From: Phil Inglis [jinglis@erols.com]
Sent: Monday, December 04, 2006 4:36 PM
To: PCTEST TCB
Cc: PCTEST - Al Cirwithian; PCTEST - Andrea Zaworski; PCTEST - Courtenay Geraghty; PCTEST - Gregory Czumak; PCTEST - Randy Ortanez
Subject: Re: Questions Regarding FCC ID: MHATML1
Attachments: SCREN235.GIF

> To: Mr. Phil Inglis / TRPFrom: Mr. Gregory Czumak / PCTEST
> TCBRE: FCC ID: MHATML1
>
> Applicant: Data Sciences International
>
> Correspondence Reference Number: MHA0771 Confirmation Number: 11270771
> Date of Original Email: December 01, 2006
> Subject: Request for additional information<?xml:namespace prefix = o
> ns = "urn:schemas-microsoft-com:office:office" />In regards to your
> recent TCB application referenced above, we kindly request that you
> provide the following additional information.
>
> 1. Please verify that the loop antenna was rotated 360 degrees on its
> vertical axis, and also placed horizontally, in an effort to maximize
> the emissions.
>
> 2. Please verify that the EUT was tested in 3 orthogonal planes.
>
> 3. There is a Restricted Band (per Section 15.205) at 8.291 –
> 8.294 MHz. The occupied bandwidth plot submitted in the test report
> appears to show that a

SCREN235.GIF (16 KB)

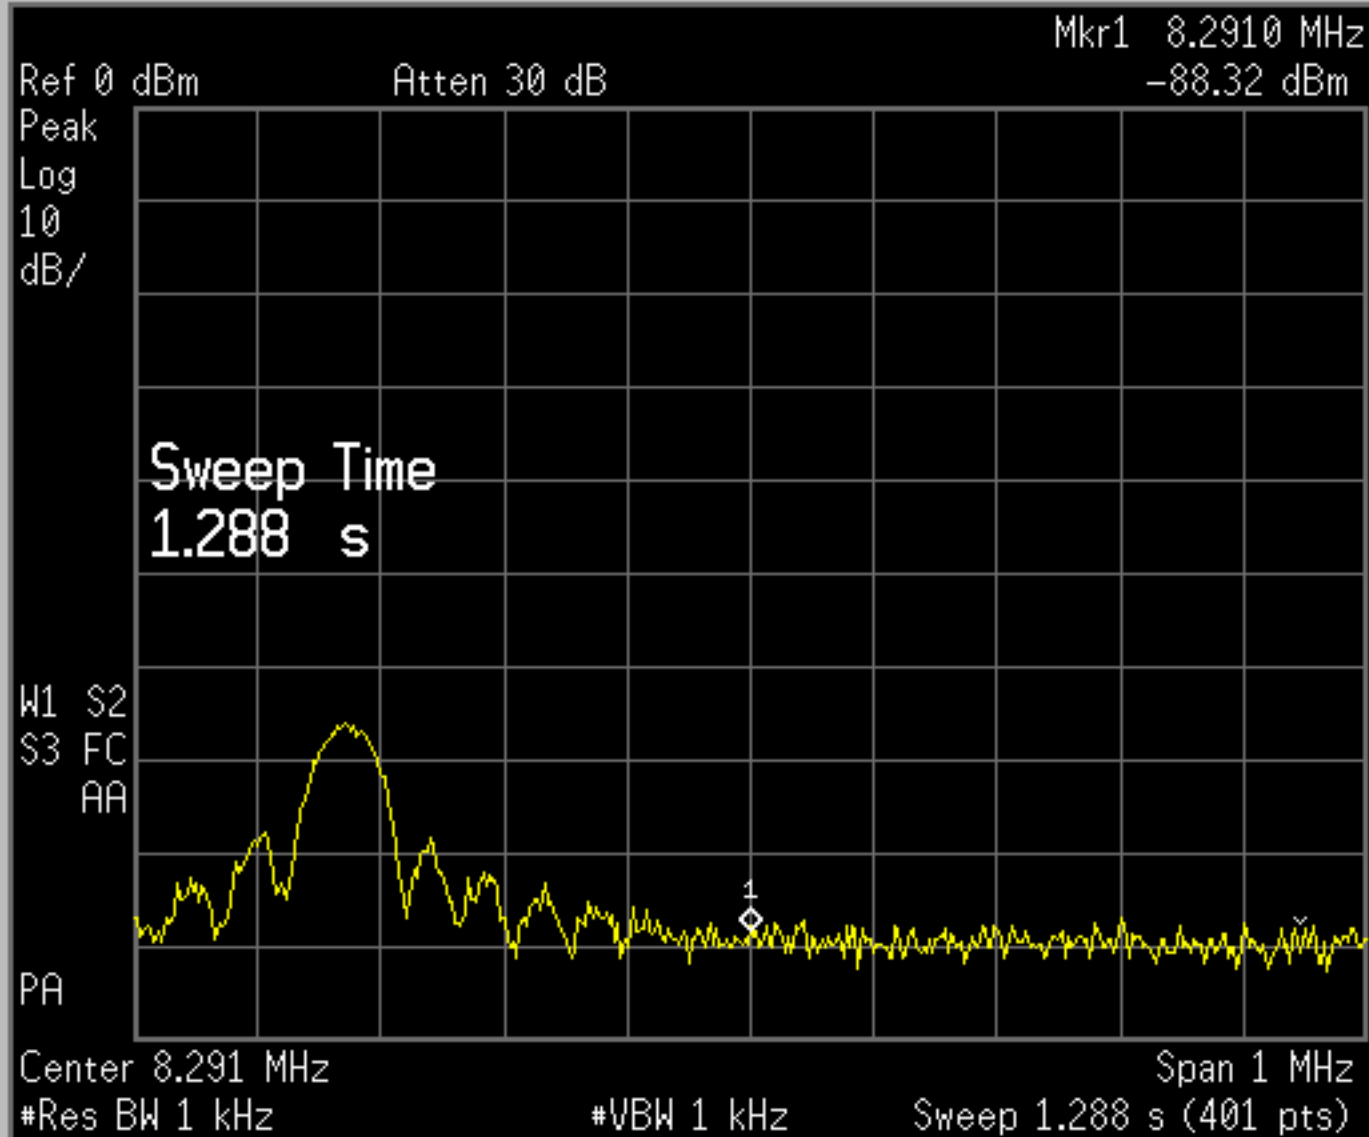
> this band. Please remeasure using a narrower RBW (still greater than
> 1% of the occupied bandwidth), and show its relation to the referenced
> Restricted Band, and submit the new plot.

1. This correspondence is to verify that the loop antenna has been confirmed to have been rotated 360 degrees on it's vertical axis and also placed horizontally in an effort to maximize the emissions.
2. This is to also verify that the EUT was tested in 3 orthogonal planes.
3. Please find the attached plot showing there are no modulation products at or above the restricted band edge starting at 8.291 MHz from the product and compliance with the FCC rules is shown. It is noted that Industry Canada has a requirement to list the emission designator on their grant. For Industry Canada it is acceptable to use 250KA1D as the emission designator.
